ATTACHMENT 2

Applicant Response Table

Property Projects Australia

Extract 1 – Previous – Streetscape (SD10-01 – Revision B)

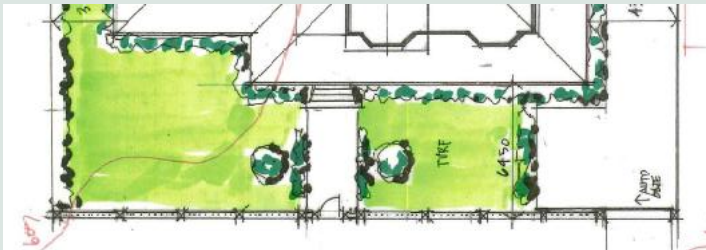
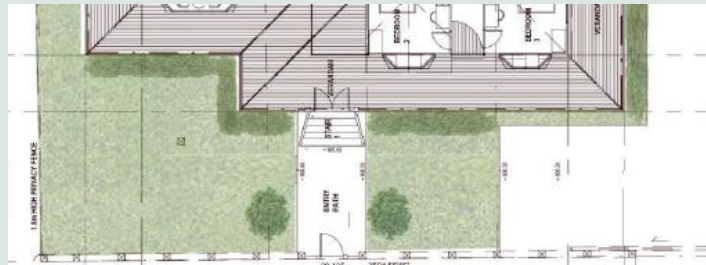
1.1(a)	Show a front door aligned with the stairs, consistent with the character of other dwellings in the streetscape	We understand Council had interpreted the following component as being a door, however, it is a stained glass	Attachment 3 – Amended Proposal Plans

and the previous character dwelling on-site. Consider either returning the second door as a window as per Approval PSW/2024/5440, or make the second door as the front entry and shift the stairs to align with the new front door

window, and the plans have been amended to explicitly identify it as such (**Extract 1** and **Extract 2**).

The front door will remain central to the staircase and continue to present as the primary entry to the building / dwelling house, consistent with the character of homes within Fogarty Street.

The proposal plans have also been amended to illustrate the window as being subordinate to the front door and the overall presentation of the front façade.	
1.1(a)	Remove the carparking and ramp / path within the site's frontage; and	The proposal plans have been amended to revert to the previously approved plans. As such, the car parking space, and additional hard stand, ramp and path have been removed (Extract 3 and Extract 4).  Extract 3 - Approved - Site Plan (SD0-02 - Revision E) Source - Elia Architecture  Extract 4 - Proposed - Site Plan (SD10-07 - Revision C) Source - Elia Architecture	Attachment 3 - Amended Proposal Plans
1.1(a)	Are clear and aligned particularly in relation to the new front door.	The proposal plans ensures there is one (1) front door along the front elevation, which is aligned with the staircase (Extract 2).	Attachment 3 - Amended Proposal Plans
